FURTHER INFORMATION

SD22B/0079

- Proposal:** Retention Planning permission for detached single storey Shed/Gym/Office to the rear garden with ancillary works
- Site Address:** 23 Church View, Gibraltar, Dublin 22 D22YD34
- Applicant:** Anthony Sterio

Fig 1.0 Shows front elevation of shed and neighbouring sheds along the boundary.

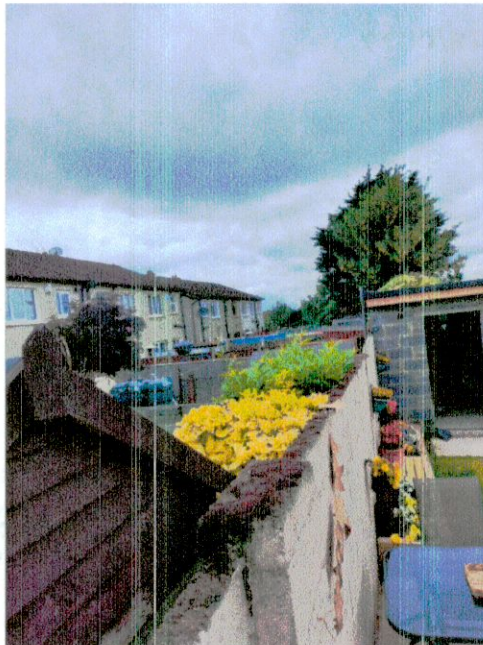
1. The planning Authority considers that the applicant has not demonstrated that the proposed development does not adversely impact on the residential amenity of neighbouring properties in the area. In this regard, the applicant is requested to submit a full suite of contiguous and sectional drawings (from all aspects), which indicate the existing ground level of the subject site and the existing and surrounding dwellings and include any other structures on the subject site and separation distances to nearby structures.

As part of the further information request we have furnished this submission with a detailed shadow analysis to demonstrate that the proposal has no impact on the residential amenities in the area.

The majority of the shadows that are casting into rear gardens are from the party boundaries and cast away towards the lane at the rear of the property.

In all instances the proposed shed/gym/office has no residential impact to the west or east of the property due to the orientation of the site and the original shadow cast by all of the boundary walls in the area.

We have also submitted drawings showing levels and additional structures in neighbouring gardens that are of similar height or taller in this area.
